SERVICE BULLETIN

INTRODUCTION OF A NEW OIL DIPSTICK FOR ROTAX ENGINE TYPE 912 AND 914 (SERIES)

SB-912-040 SB-914-026

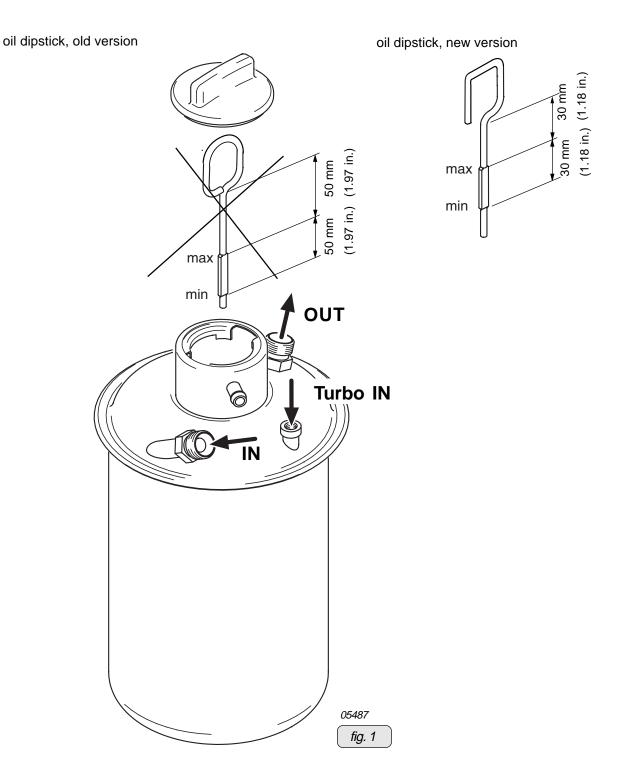
Fig.no.	New p/n	Qty/engine	Description	Old p/n	Application
(1)	956151	1	oil dipstick	956150	oil tank

- Remove the oil dipstick part no. 956150 and replace by new oil dipstick part no. 956151.
- Inspect the oil level to be performed SI-27-1997 "Oil level check", current issue.
- Add oil if necessary.
- ◆ NOTE: By changing the oil dipstick, the minimum oil level is raised by approx. 40 mm (1.57 in.) and the height between the "min." and "max." level is reduced to 30 mm (1.18 in.) (approx.0,45 litre).
- Restore aircraft to original operating configuration.
- Connect negative terminal of aircraft battery.
